Appendix H: RFLMA Contact Records

Summary of RFLMA Contact Records

ROCKY FLATS SITE REGULATORY CONTACT RECORD

Figure 1. Time-series plot of analytical data from Table 1 together with calculated regression best-fit trend and corresponding R² value.

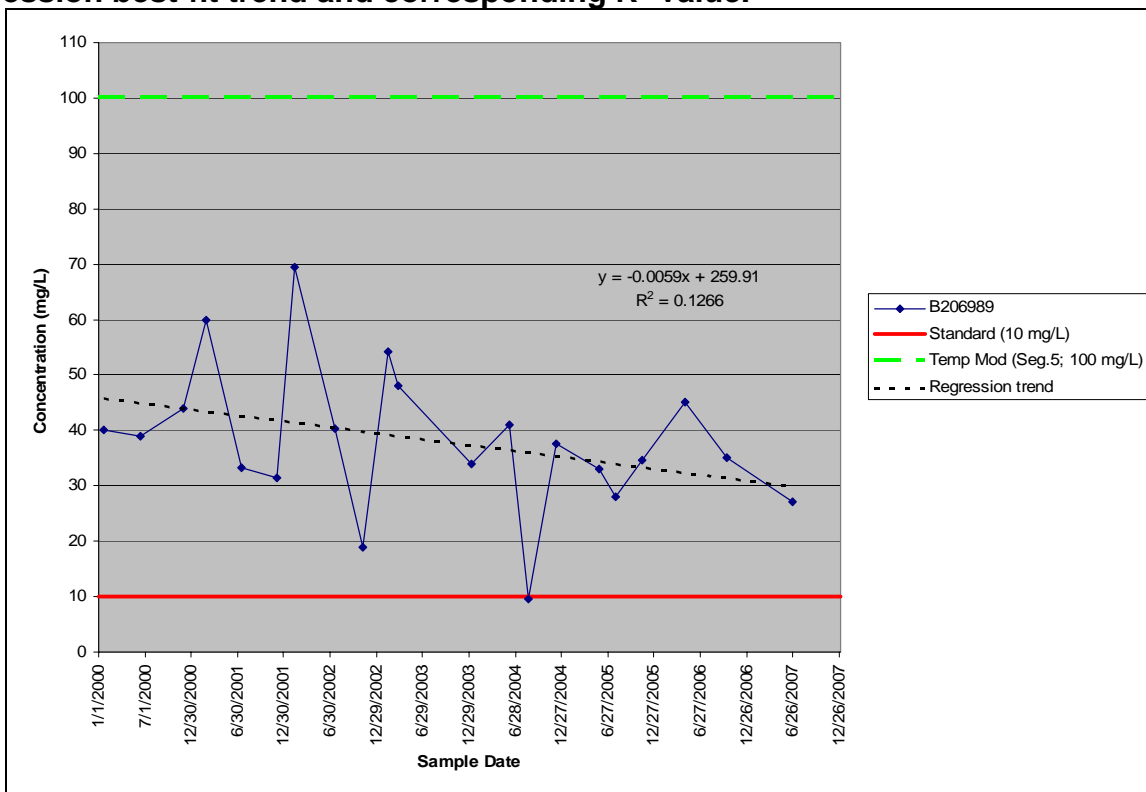
Figure 1 presents these data in a time-series plot, and includes a best-fit regression trend line. The r^2 value, 0.1266, suggests the fit is not particularly good. This is to be expected given the variability of the data. Even so, the visually apparent overall decrease is confirmed.

Figure 2. Plot of analytical data from Table 1 together with calculated Seasonal-Kendall trend.

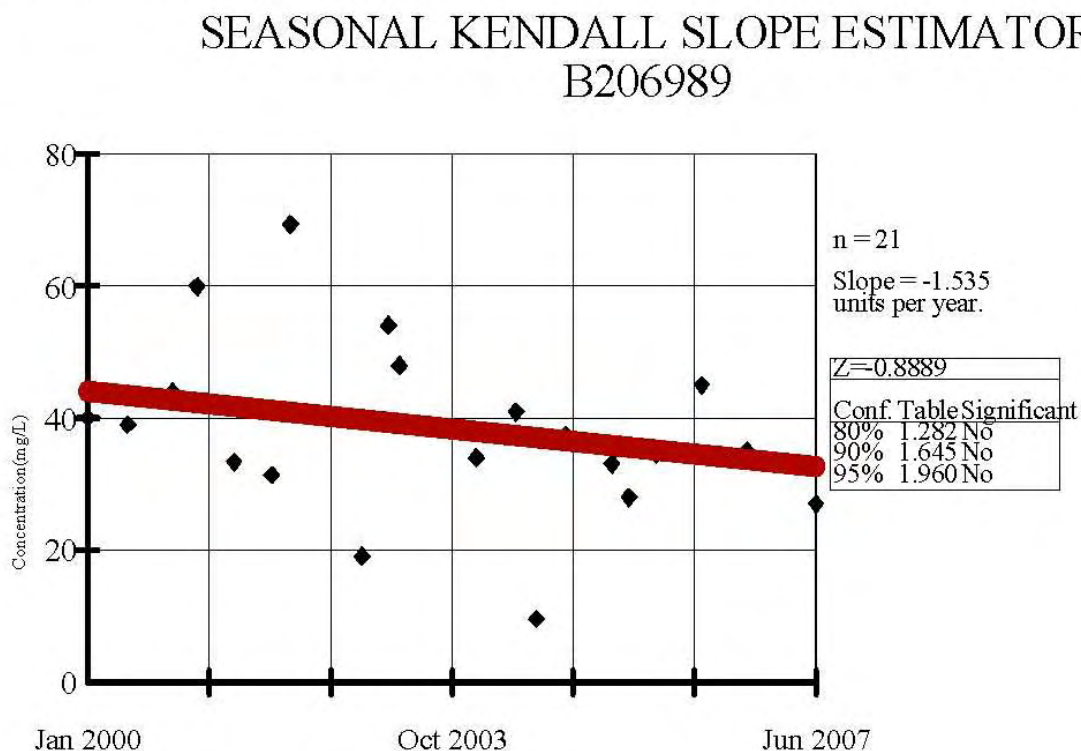
Figure 2 shows the same data, but includes a trend calculated using the Seasonal-Kendall trending method. Once again, a decreasing trend is evident. But again, the statistical confidence is not high; as shown, the trend does not meet an 80% level of significance.

5. If the level of significance of the nitrate trend still has not reached 80% following receipt of data from the last routinely-collected sample in calendar year 2011, and a subset of the nitrate results from the most recent 8 routine semiannual samples also lacks this level of significance, the DOE and CDPHE shall consult to determine whether an alternative to or modifications of this strategy are warranted based on all then-available data. (The date 2011 is arbitrarily selected to encompass the next CERCLA 5-year review period; the minimum number of samples required to calculate a Seasonal-Kendall trend is 8.)
